LOST CREEK III MASTER DEVELOPMENT PLAN

MDP# 828

ATTN: John D. Adame, P.E.
RE: Lost Creek III Master Development Plan (MDP)

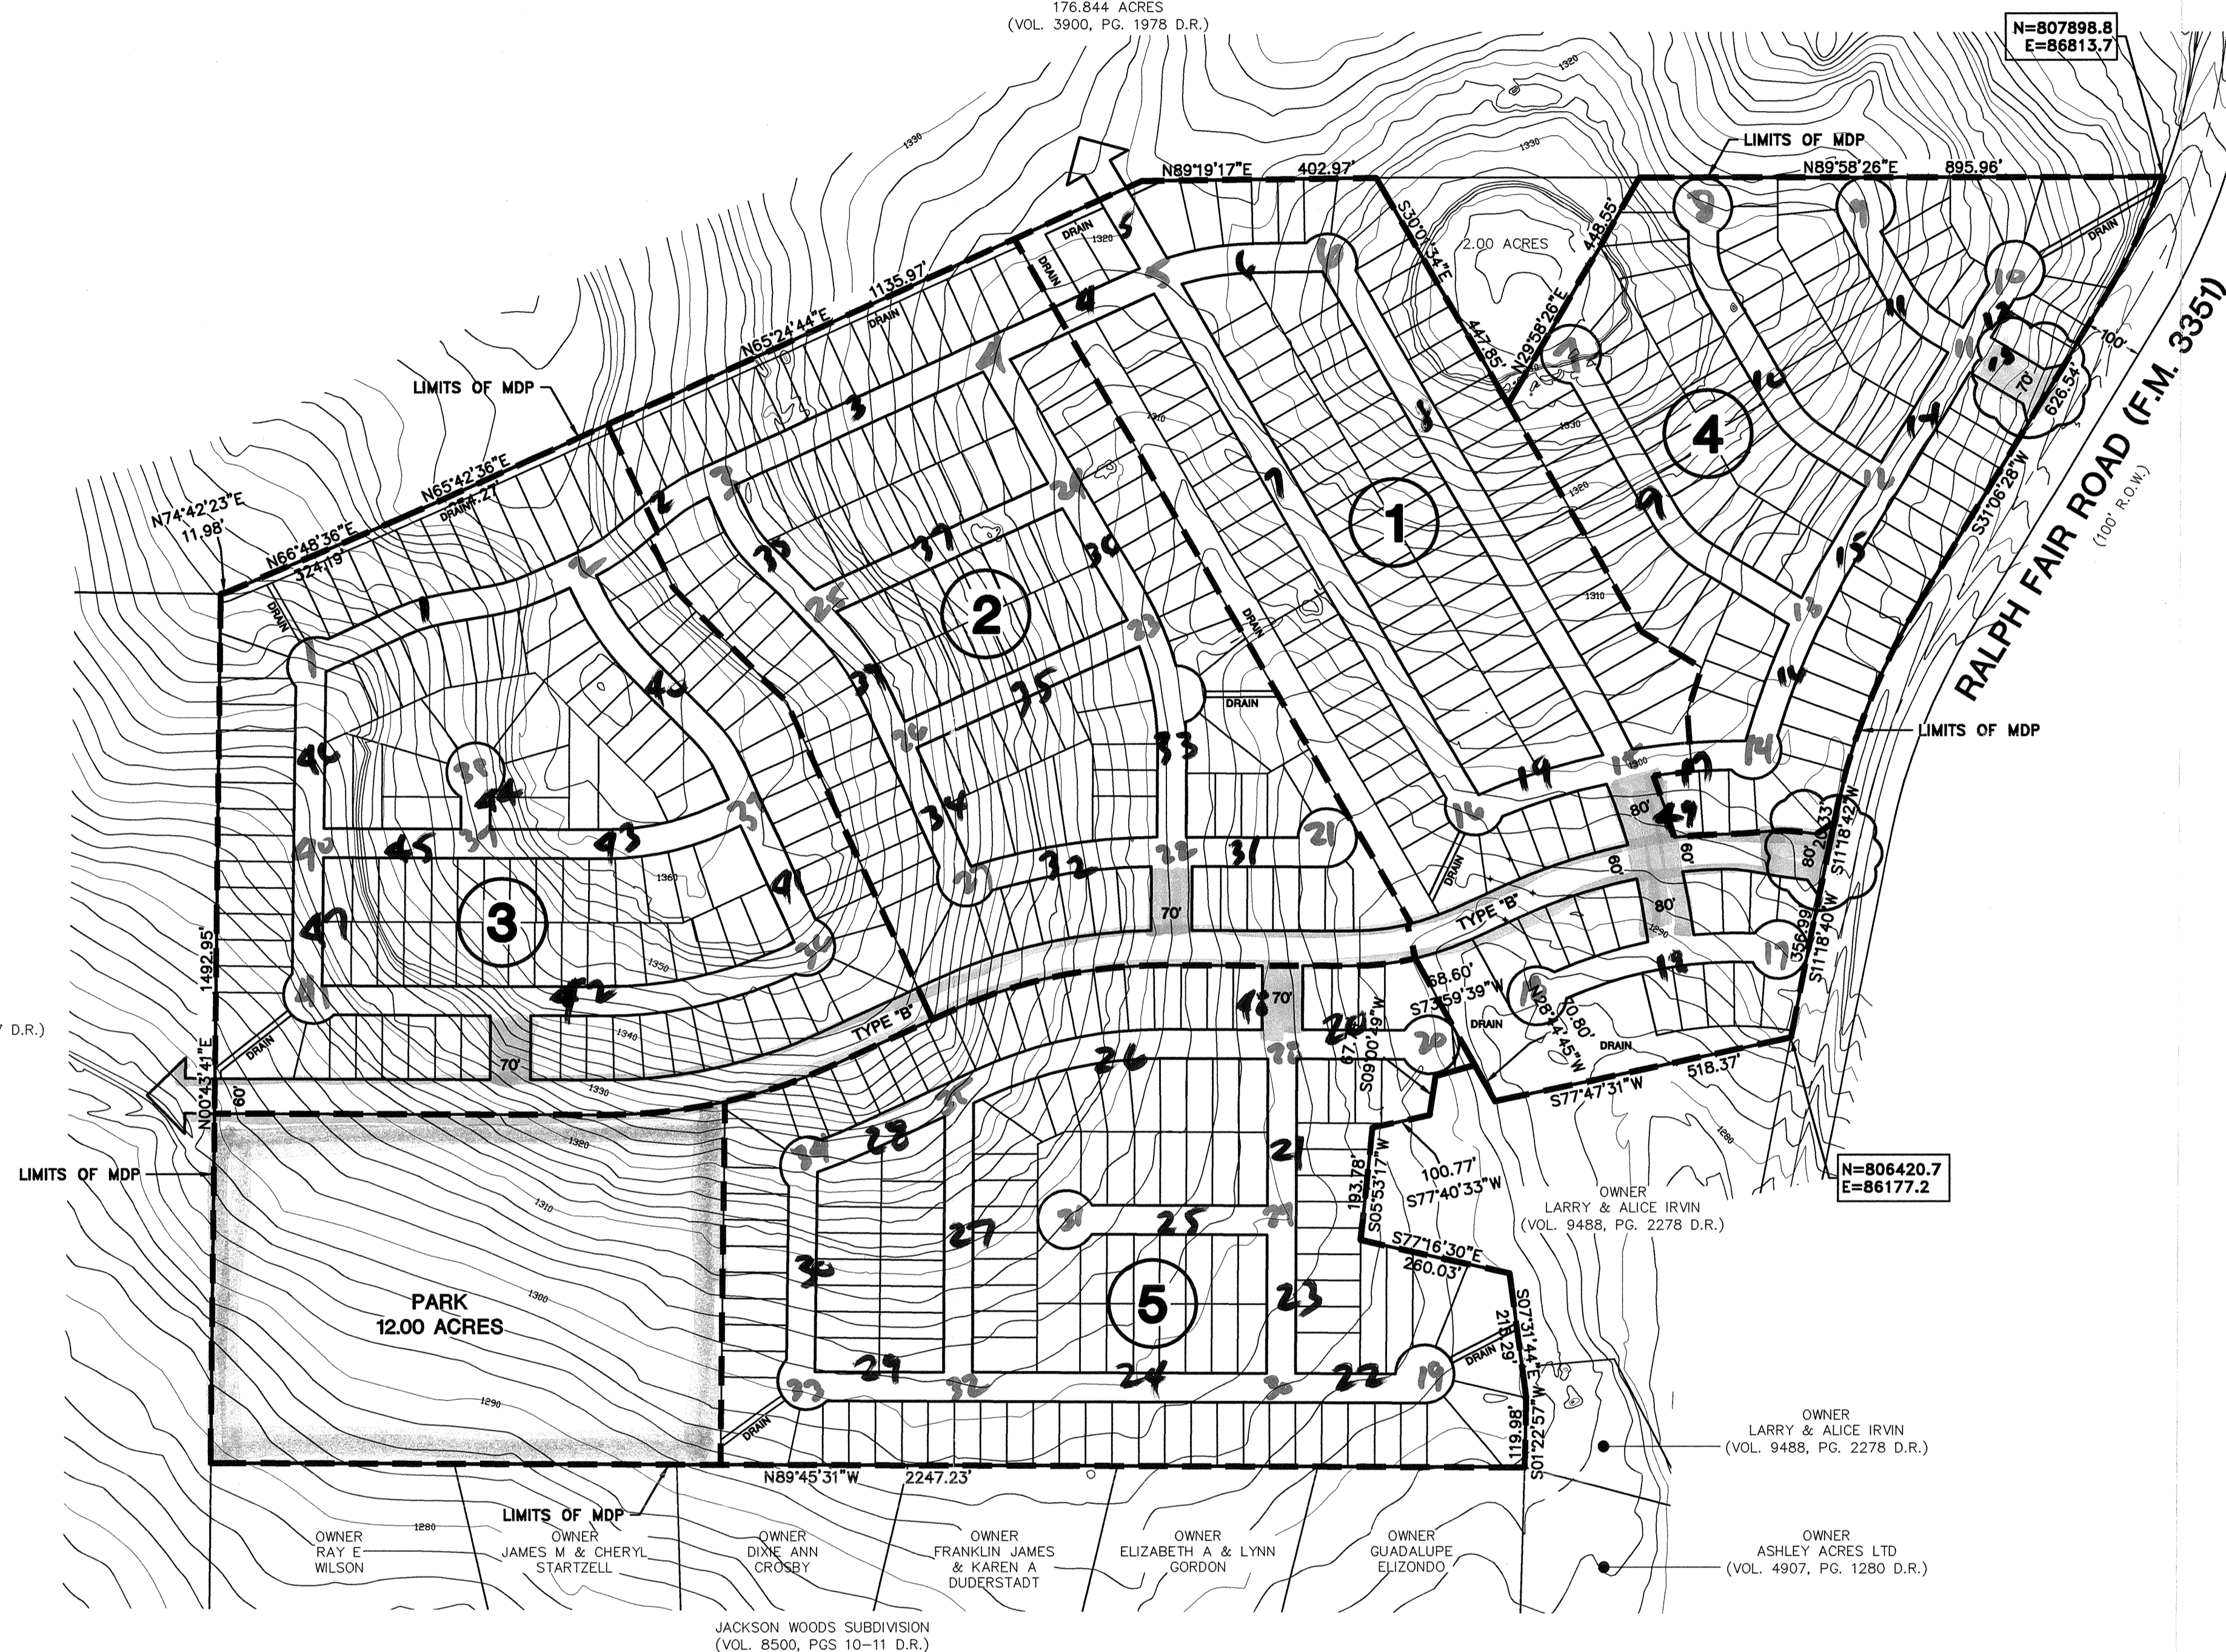
CORRECT NORTH ARROW

② THE TIME OF
FINAL APPROVAL
PLAN WILL SHOW
CORRECT NORTH
ARROW
